**BOROUGH OF HIGHLANDS
LAND USE BOARD MEETING**
22 Snug Harbor Avenue, Highlands NJ 07732
Thursday, February 10, 2022 at 7:00 PM

KAPLAN RESIDENCE ~
NEW PRIVATE RESIDENCE

As requested, our office has reviewed the above referenced application for minor subdivision plan approval. The applicant submitted the following documents in support of this application:

DRAWING NO:
A201

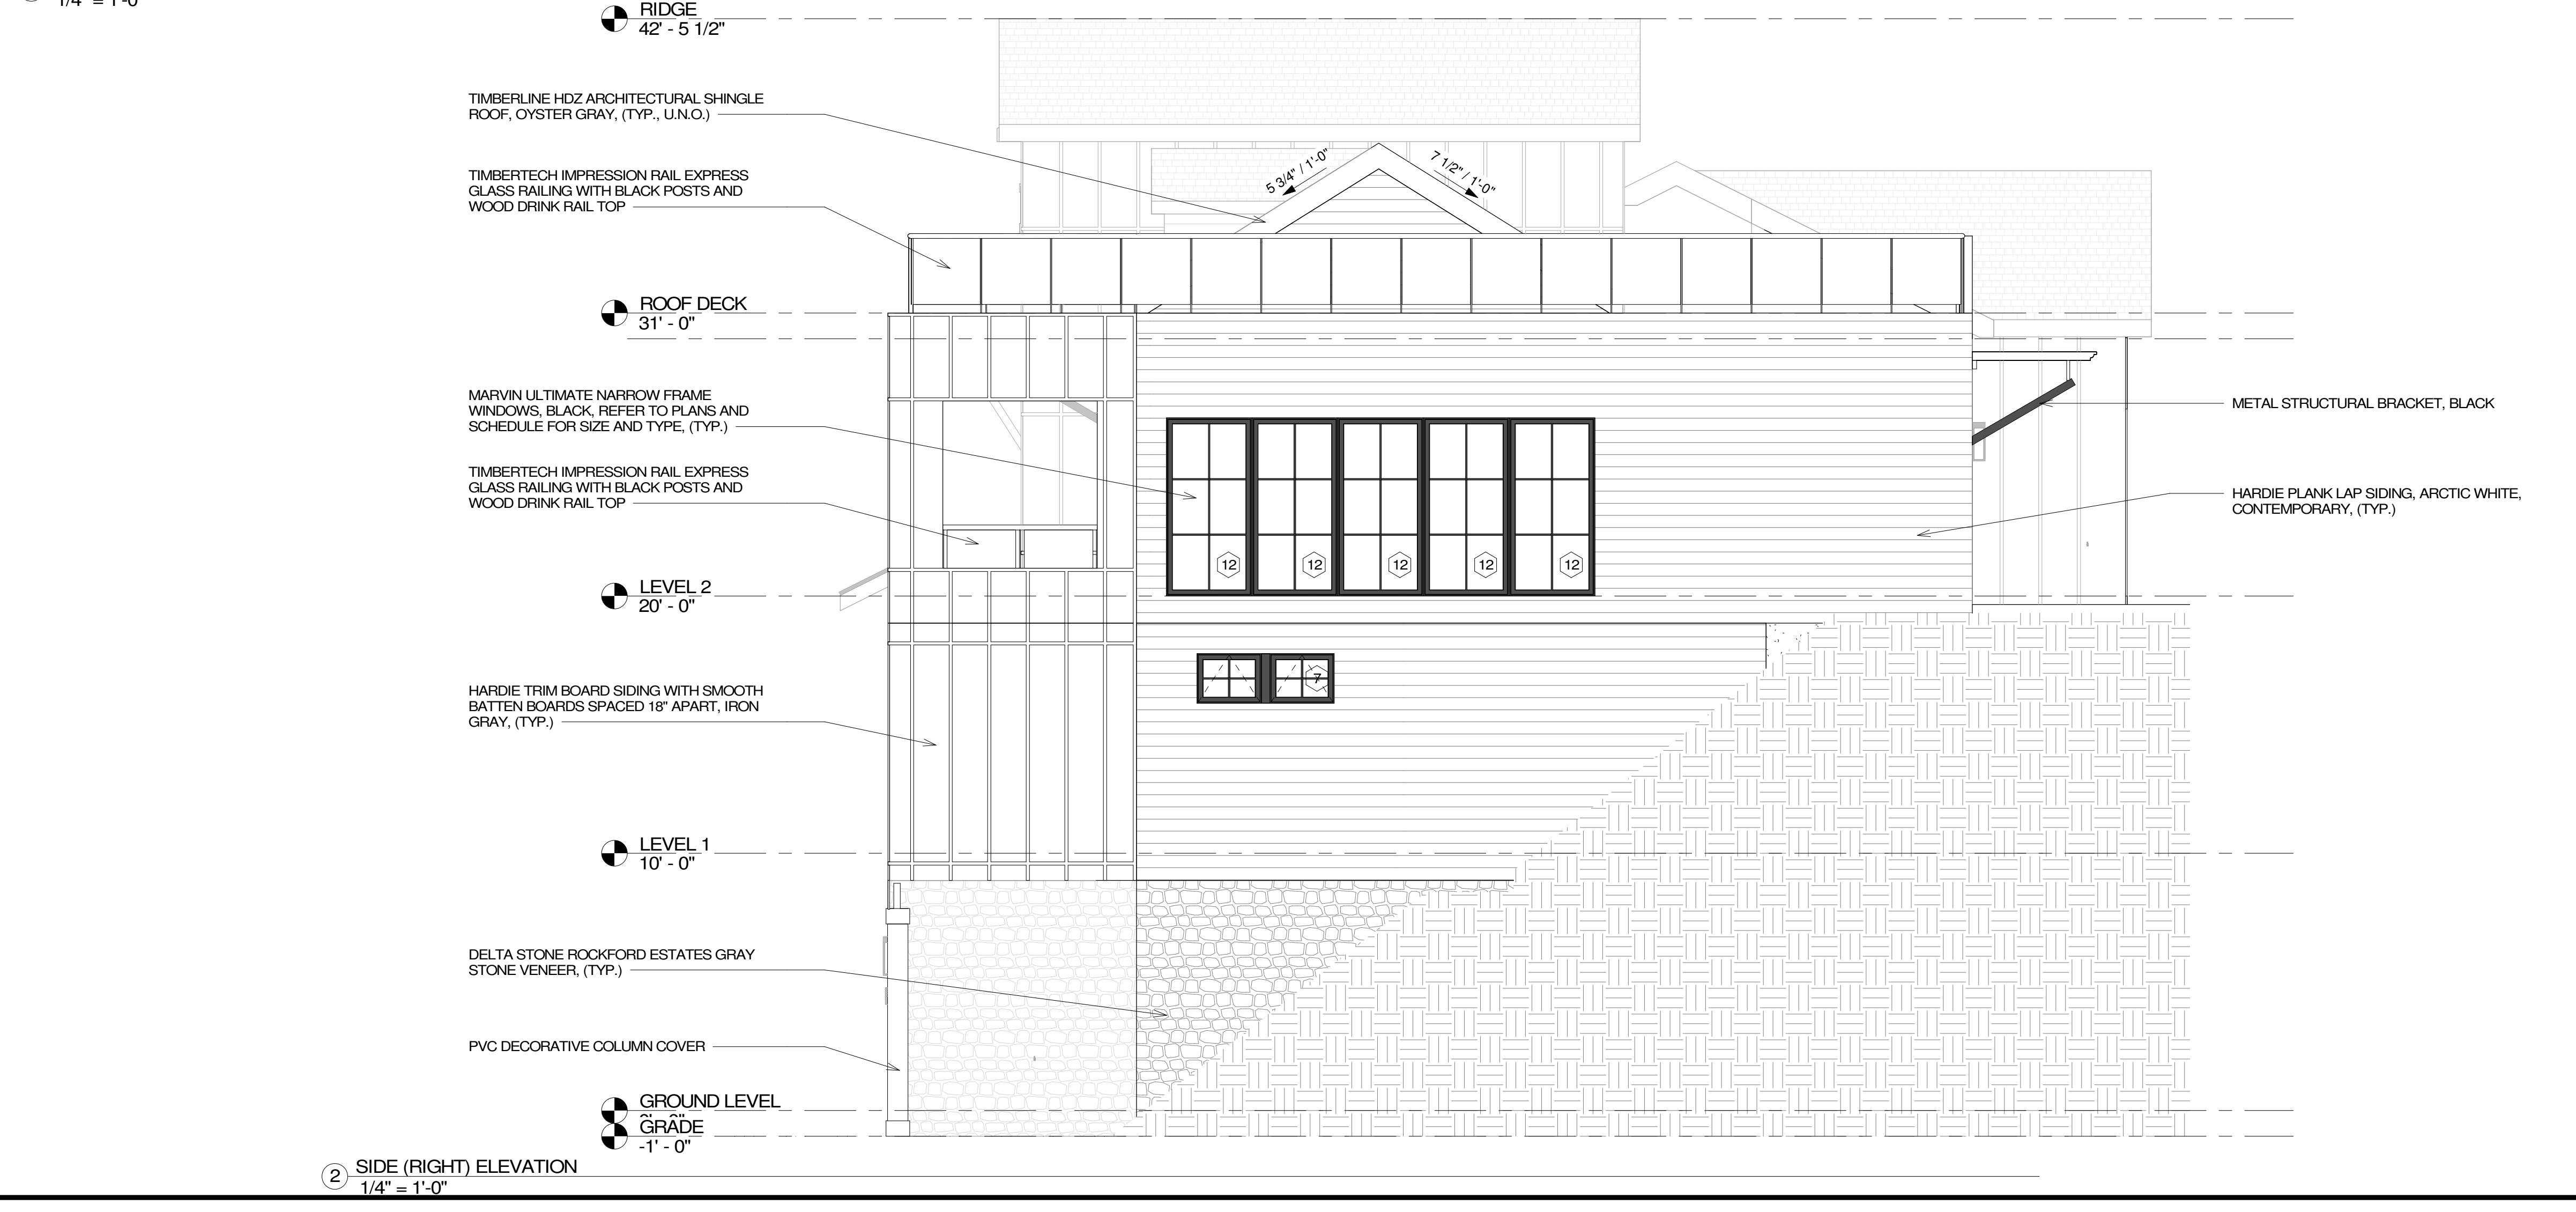
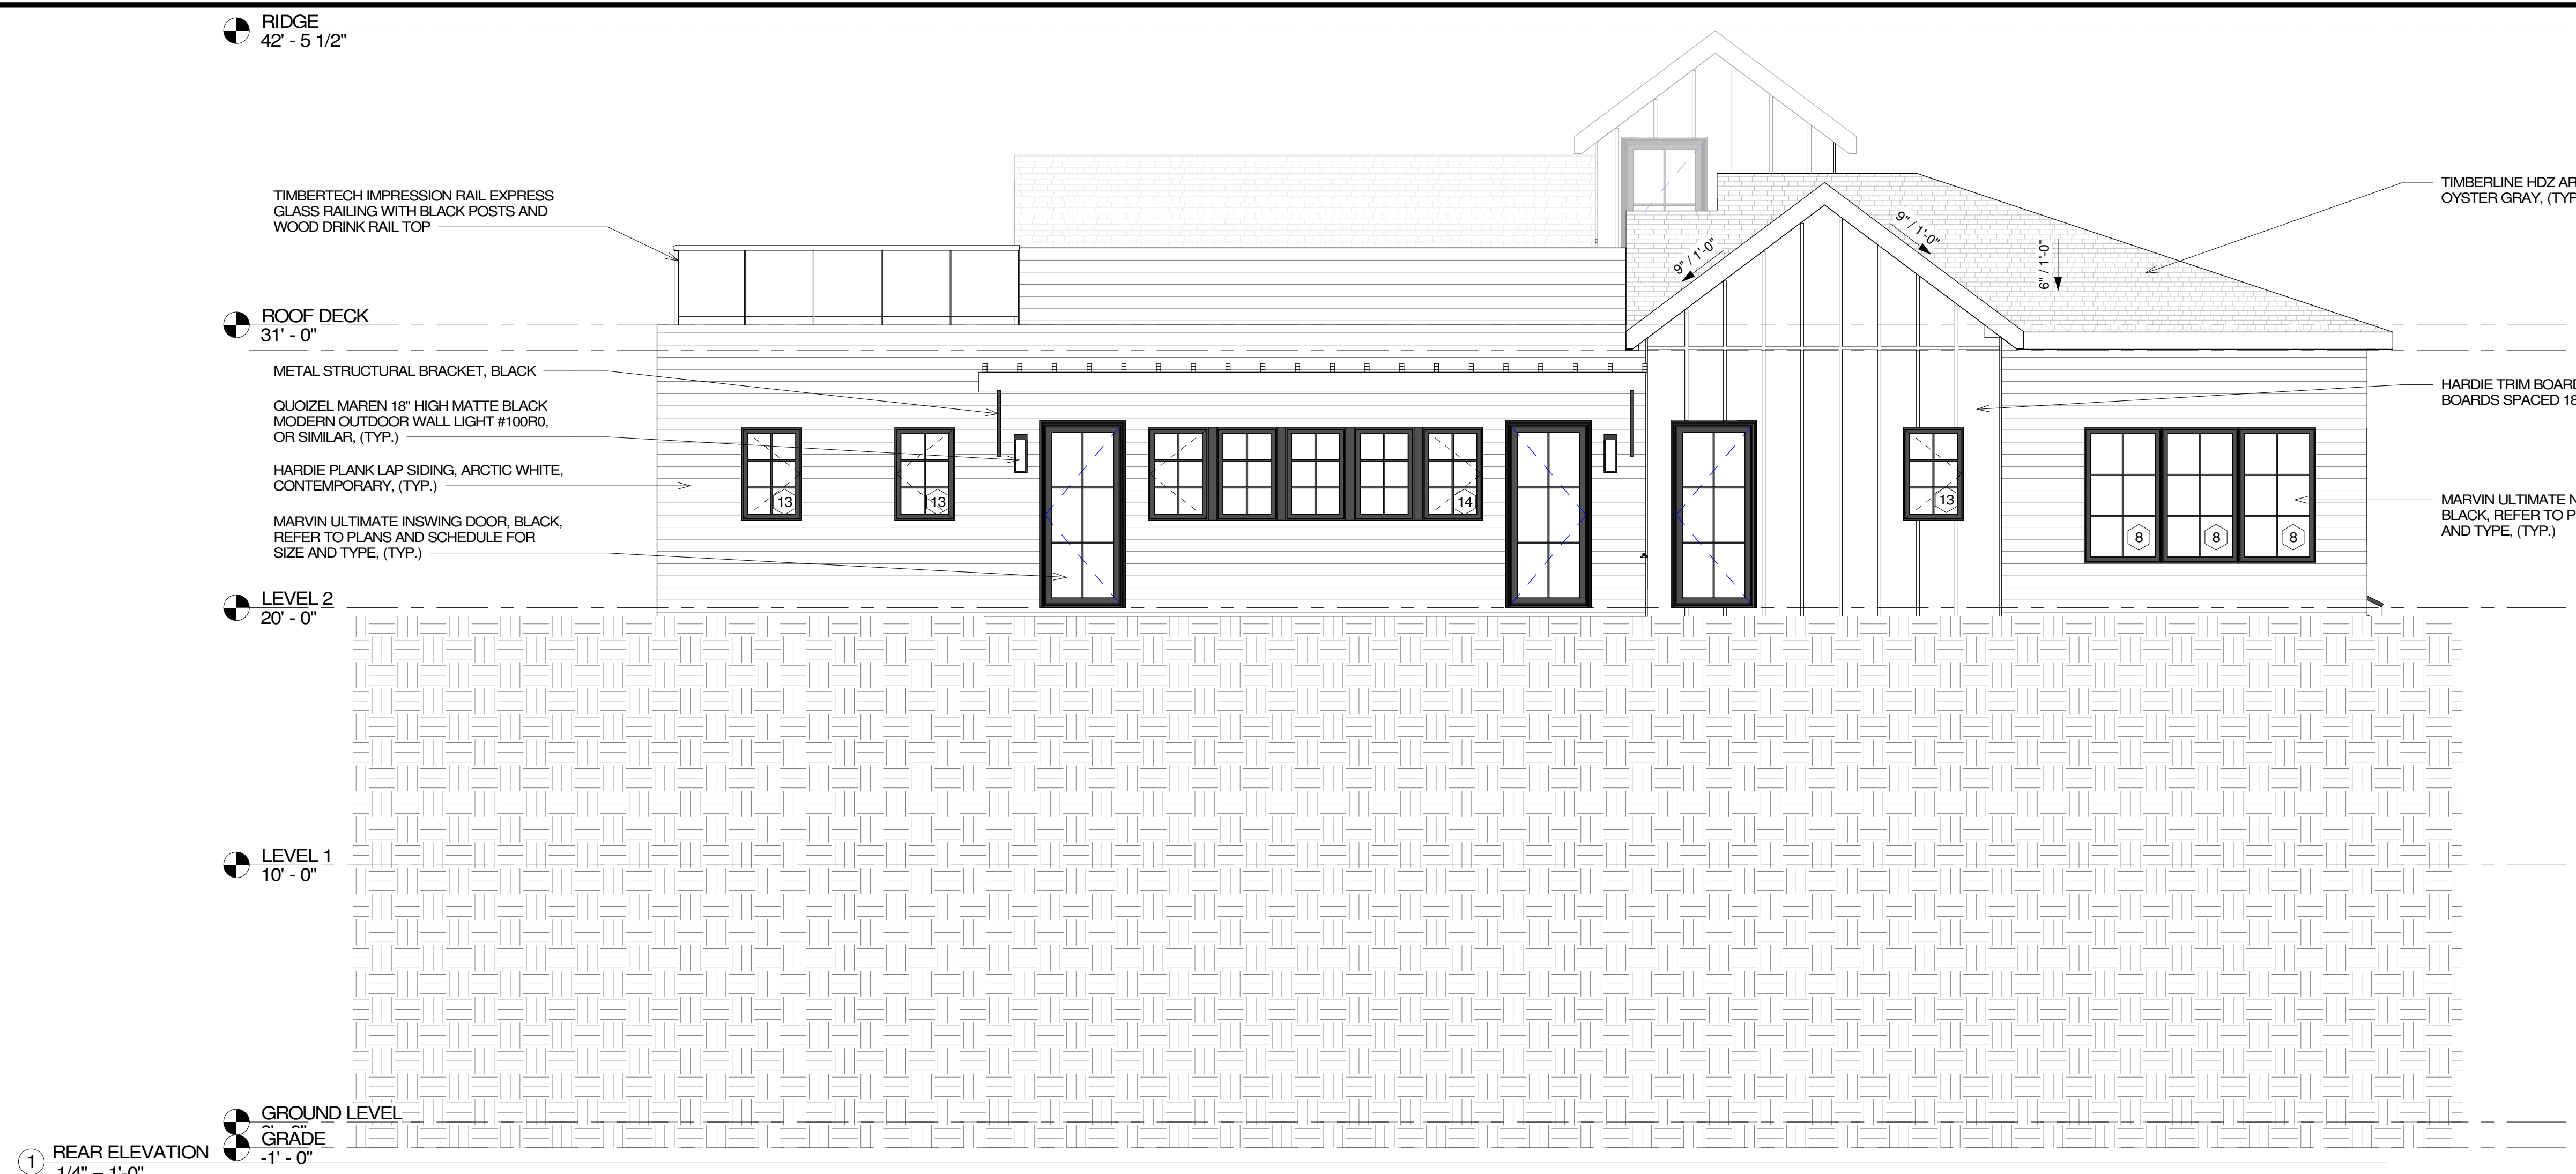
Based on our calculations, the average grade plane is at approximately elevation 122.05. The Architectural Plans show the building height from elevation 115 to the top ridge as 42.46 feet, and the to the lowest eave as 31 feet. By definition the true building height is calculated as the difference between building height elevation and average grade plane elevation. Therefore, we calculate the true building height as 29.68 feet, whereas the Zoning Table indicates a building height of 26.99 feet. This discrepancy shall be addressed, and the appropriate calculations shall be shown on the plans.

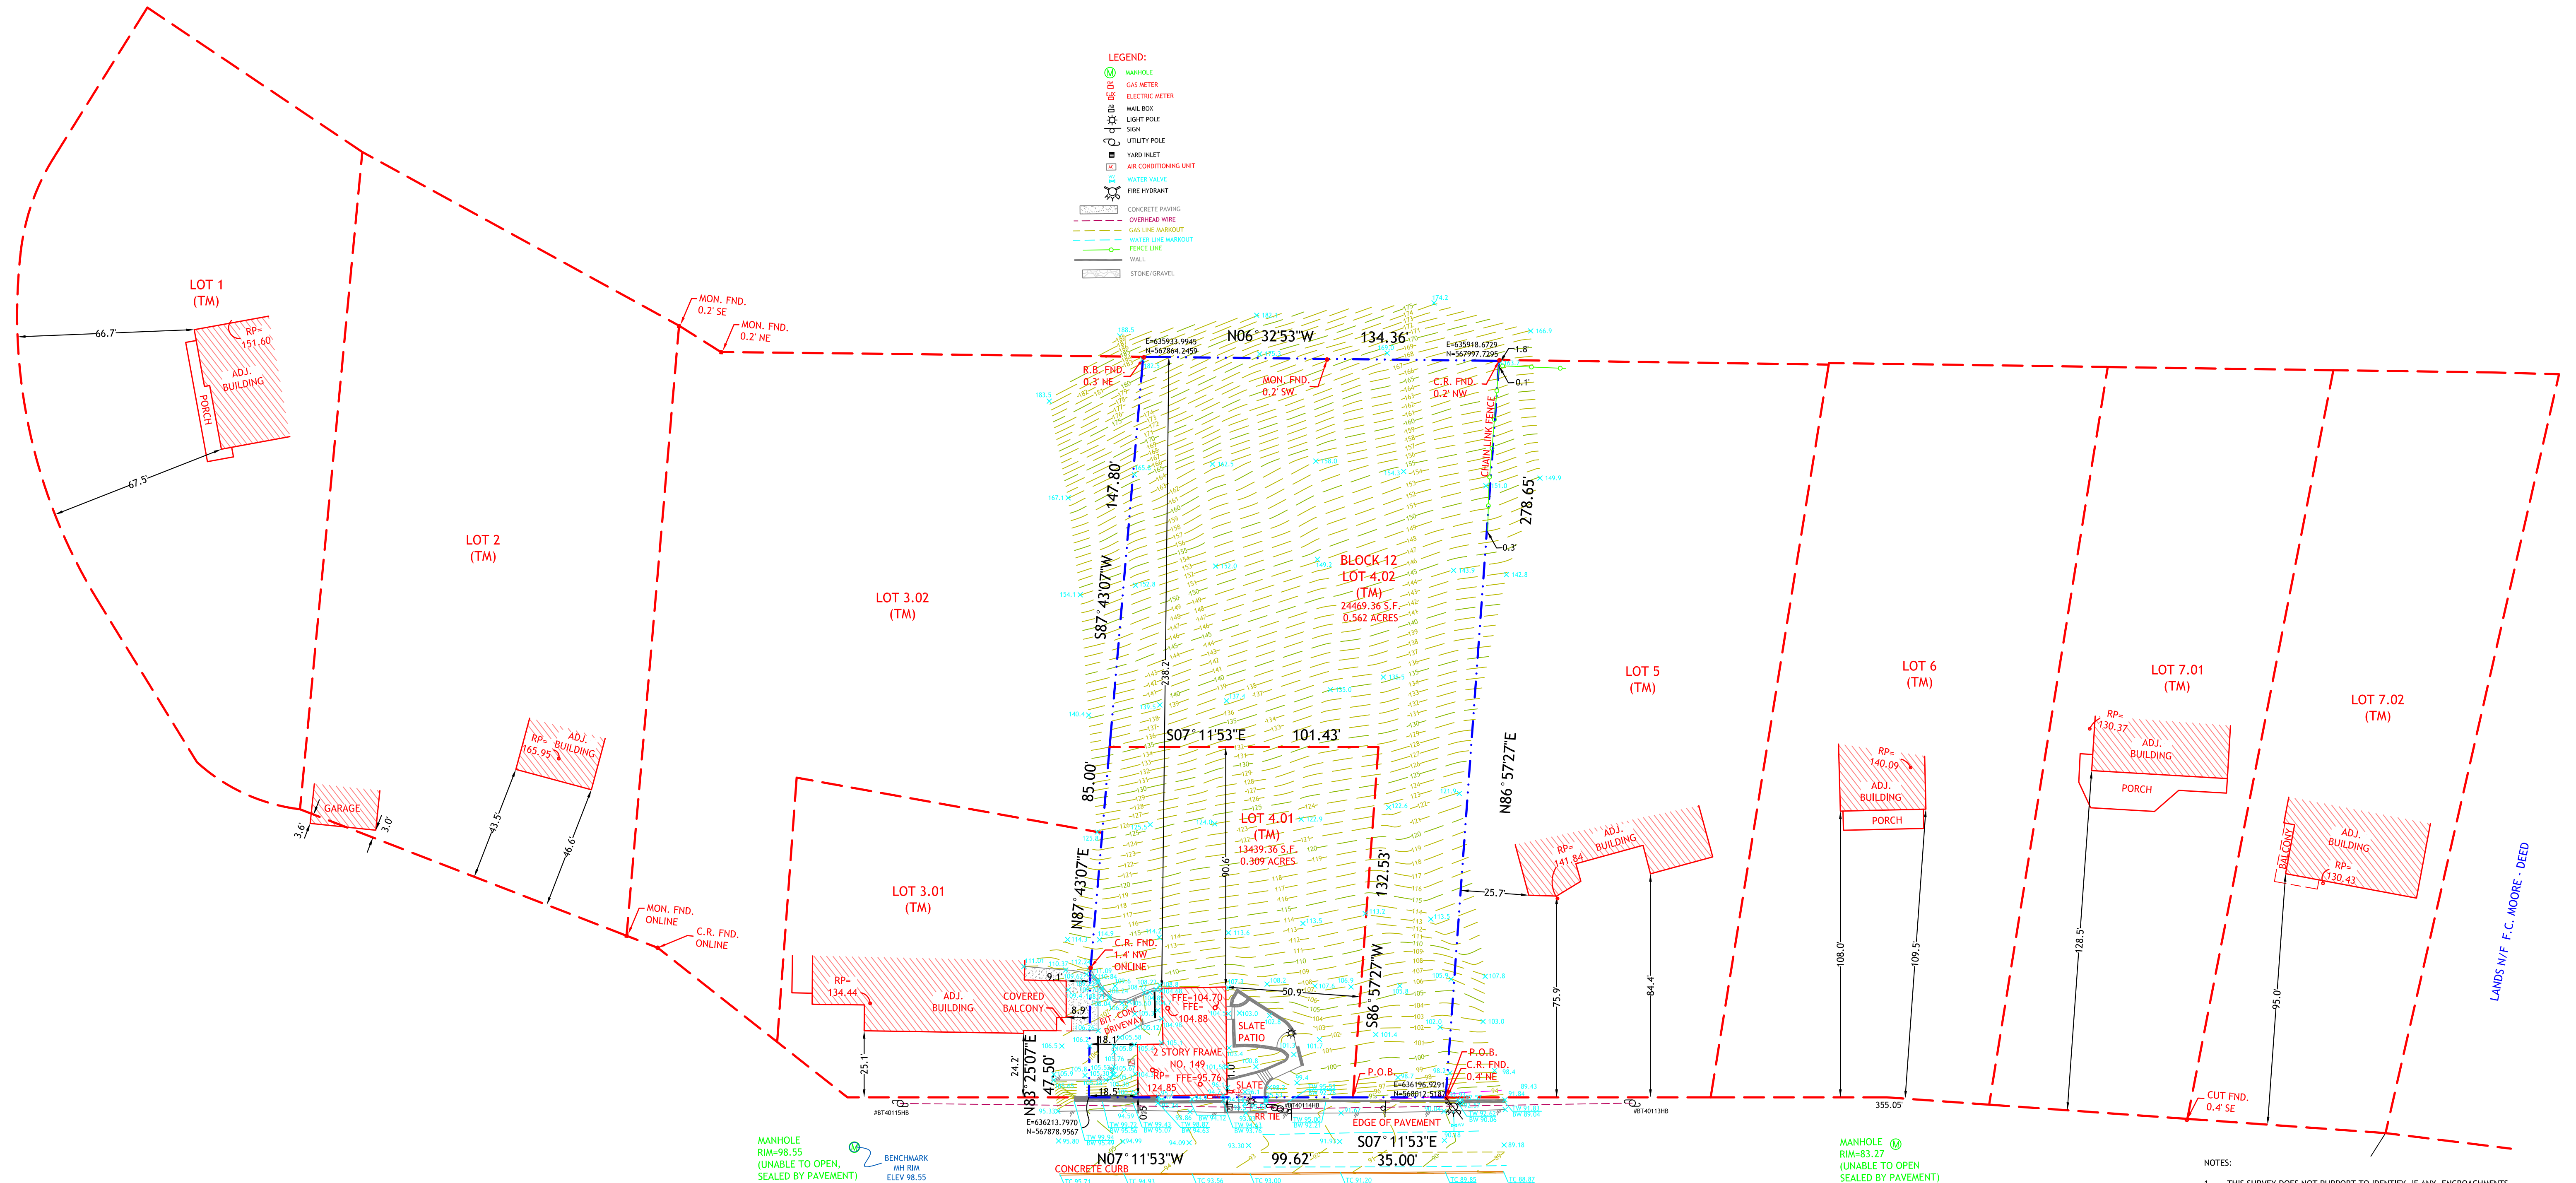
- b. Section 46:26.B-2.b.8 of the Map Filing Law requires a minimum of three corners distributed around the tract shall indicate coordinate values. This coordinate base needs to be either assumed or based on the New Jersey Plane Coordinate System and shown on the map.

- d. A Key Map shall be provided.
 - e. A listing of owners within 200' shall be provided on the map.
 - f. The north arrow needs a reference meridian.
 - g. All appropriate certifications as deemed necessary in Section 46:26.B-2.b of the Map Filing Law including but not limited to surveyor preparing the map, surveyor who prepared the boundary survey, municipal clerk, Planning Board, owner, and applicant, with appropriate titles, shall be provided on the plan.

presented from the custodian of tax records to that effect. **Not provided. Owner’s list shall be provided on the plan. It should be noted that the owner indicated on the plans differs from the owners listed on the development application. This discrepancy shall be addressed, and the correct owner indicated on all documents.**

- 12. Certification statement for the required municipal signatures, stating: **Not provided. Certification statement shall be provided on the plan.**
 - o Application No. _____ approved/disapproved by the Highlands Borough Planning Board/Board of Adjustment as a Minor Subdivision on _____.
(date)
